DATE: March 9, 2017

SUBJECT: Traffic Signal Backplate Standardization

FROM: Richard N. Roman, P.E., Director
Bureau of Maintenance and Operations

BACKPLATE FOR VEHICULAR SIGNAL HEAD **HEAD***

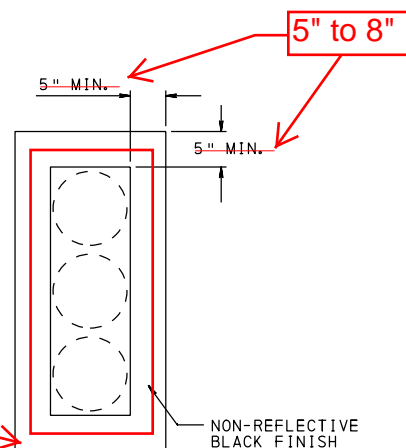
2" MIN. FLUORESCENT YELLOW RETROREFLECTIVE BORDER

*BACKPLATE SHALL BE ONE-PIECE ALUMINUM

- 1) Publication 408 (pages 955-1, 1104-21, and 1124-2):
 - a. Section 955 has been changed to follow the traffic signal backplate information relayed in section 1104.
 - b. Section 1104 has been changed to state that traffic signal backplates shall be one piece aluminum, black, between 5 and 8 inches, and include yellow retroreflective tape around the edges among other items.
 - c. Section 1124 has been changed to reference section 1104 in regards to backplates.
- 2) Publication 149 (pages 6-5, 16-12, and 20-14): changes are to reference the Publication 408, Section 1104 for how traffic signal backplates should be installed, along with showing several references to traffic signal backplates being standardized.
- 3) Publication 148 (TC-8805 page 1 of 1): change to section TC-8805 drawing diagram of a typical traffic signal backplate setup as described in Publication 408, section 1104.
